C S Stokes and Associates Limited

17th September 2014

Subject: Grenfell Tower Grenfell Road London W11 1TQ

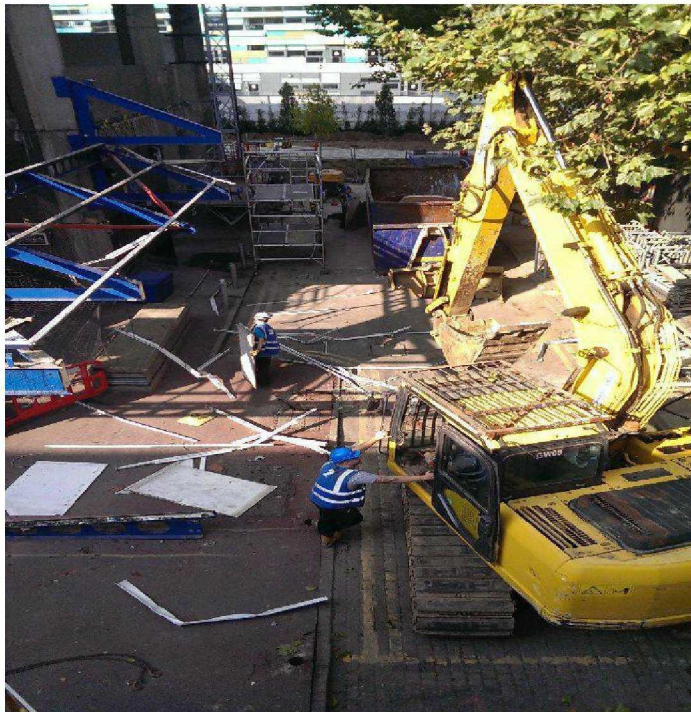
The area directly outside the building and to the left hand side of it is being used by the contractor as part of the building site and these areas are now not available to be used by other persons as they are within the fenced off site area. The left hand side area of this building has always been an area designated for "emergency use only" and a barrier was erected to restrict access to this area. While the Academy was being constructed the local Fire Safety Officers of the LFB were insistent on this area being maintained completely clear. The Rydon's project manager told me yesterday that the TMO surveyor Mrs Claire Williams said that they can use this area as part of their site and that the operational LFB crews have not commented that the area should remain clear during their site visits. To comply with the requirements of the Building Regulations, Approved Document B Part 5 there should be a clear area for fire service use directly outside of this building so that there is parking for the fire appliances and a working area to comply with the requirements to use the dry rising main installed within the building.

4. Can it please be confirmed by the LFB fire safety team that the present parking and access arrangements are suitable to them and that they were consulted before the arrangements were put in place? I would recommend that this conformation is in writing and by a suitable qualified person within the LFB. If there has not been any agreement or the LFB are not happy with the present arrangements then the emergency parking area must be reinstated immediately along with the access barrier to control parking in this area.

Hoarding at the road level.

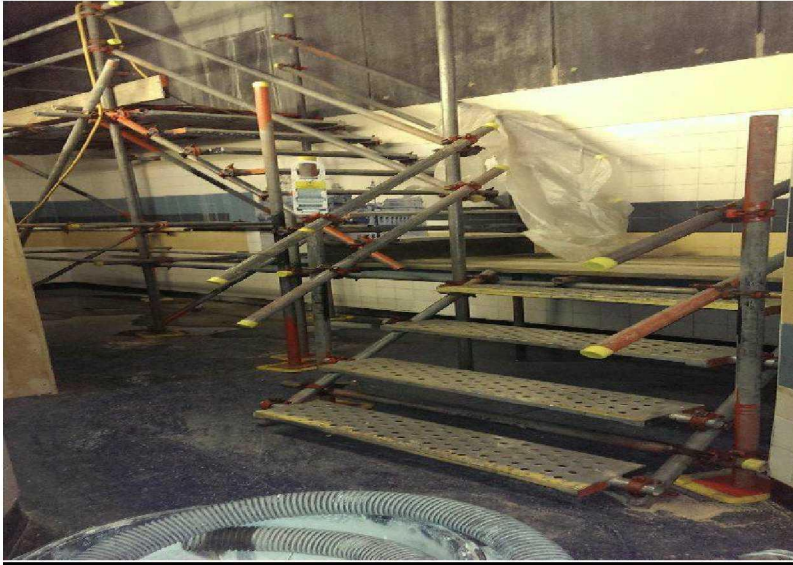
Hoarding has been erected in front of the lift doors so a person is trapped in this small gap if they exit the lift, this has been like this since the start of this month, I was told that the hoarding is to be removed this week. When it is removed there will be a scaffold staircase up to the site office, this is the only way out of this area and the only way out of the site office while the demolition of the upper part of the external staircase is undertaken. This part of the old lift lobby area will then be partition off from the remainder of the ground floor area.

5. Can it please be confirmed that the TMO are happy with this access and egress arrangement for residents of this building? , there will only be single travel at certain times and the Building Regulations only allows 18 metres for a single

travel distance. This is in effect a basement area as you have to go up to leave the building.

6. Has this access arrangement been considered under the Equality Act and for disable persons to use, including the staircase?

The controls for the smoke vents in the finger blocks are still located in the old reception area.

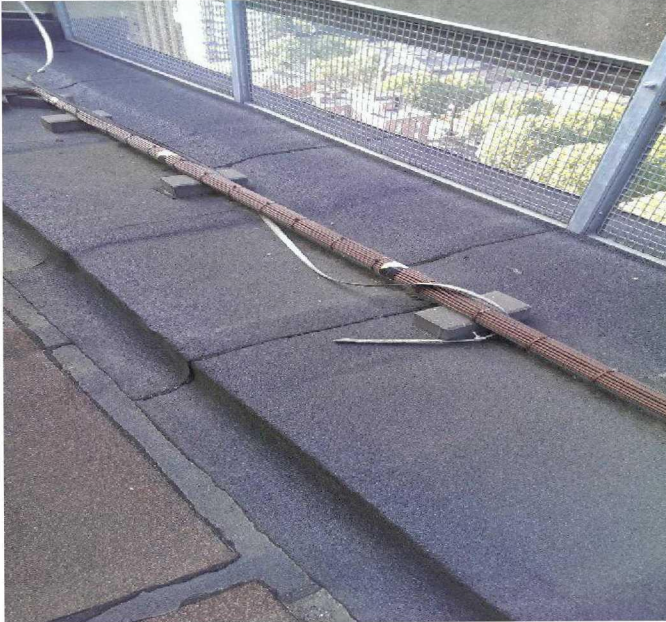
16. What are the access arrangements to these smoke control panels, especially when the contractors are off site?

Cables on the floor and drains blocked

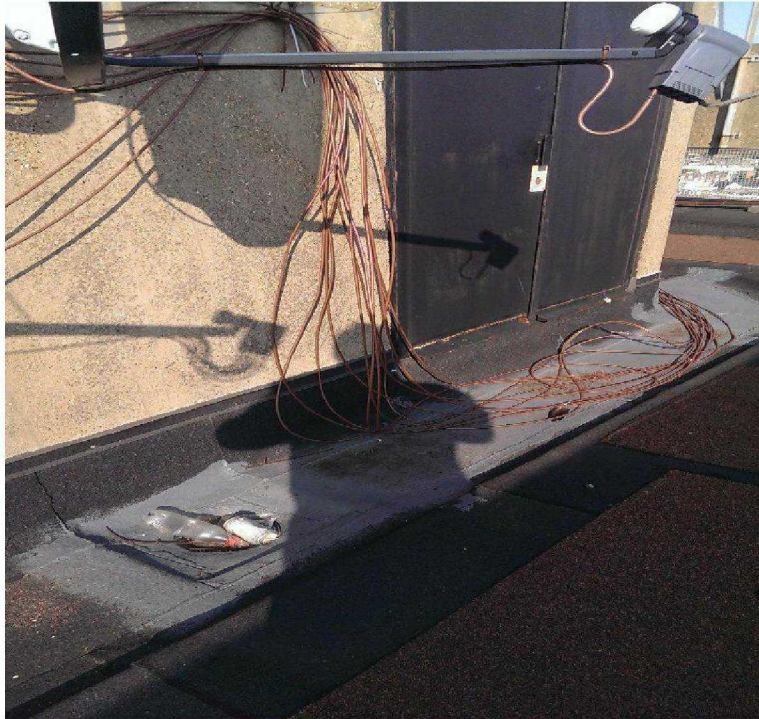
Work has been undertaken by "SCCI Alphatrack" to relocate satellite disks positioned on the face of the building to the roof level, the lightning protection system on this building has been wilfully damaged and this company have left cardboard boxes at the roof level obstructing the means of escape. The door to the external roof is damaged and does not close, there is waste and rubbish blocking the drains at the roof level and the cables are obstruction the doors to the plant areas and laid on the floor causing a

trip hazard. Under the FSO it is an offence to wilfully damage fire safety equipment in or on the building whether these are fixed systems or portable ones, a person who commits an offence, this is criminal law, can be imprisoned for up to two years or an unlimited fine.

17. The installed lightning protection system on this building should be repaired immediately and a completion and or a commissioning certificated issued by the contractor to state that the system is in full working order.
18. All the rubbish should be removed from the roof level and the drains unblocked etc.
19. The door to the external roof area should be repaired or replaced and locks etc fitted so that it can be secured shut.

Cables

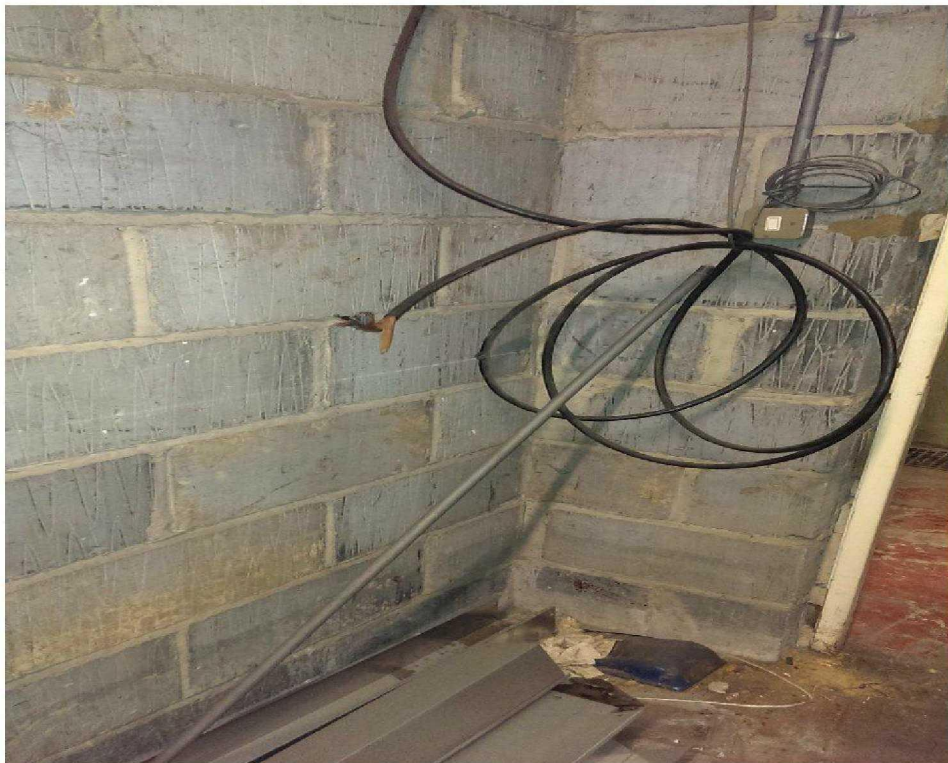
Work is being undertaken in the basement area of this building, new boilers will be installed etc, the door at the base of the staircase is damaged and there are electrical cables hanging down from the ceiling etc.

22. Can it please be confirmed by the contractor that all cut and hanging electrical cables in the basement area are not live?

23. The damaged door and door frame at the base of the staircase down to the basement should be repaired or a new door set installed.
24. The amount of combustible waste in the basement area should be kept as low as possible, with rubbish and waste removed at regular intervals, I would recommend that the contractor is asked to tidy up and remove combustible waste from this basement area.
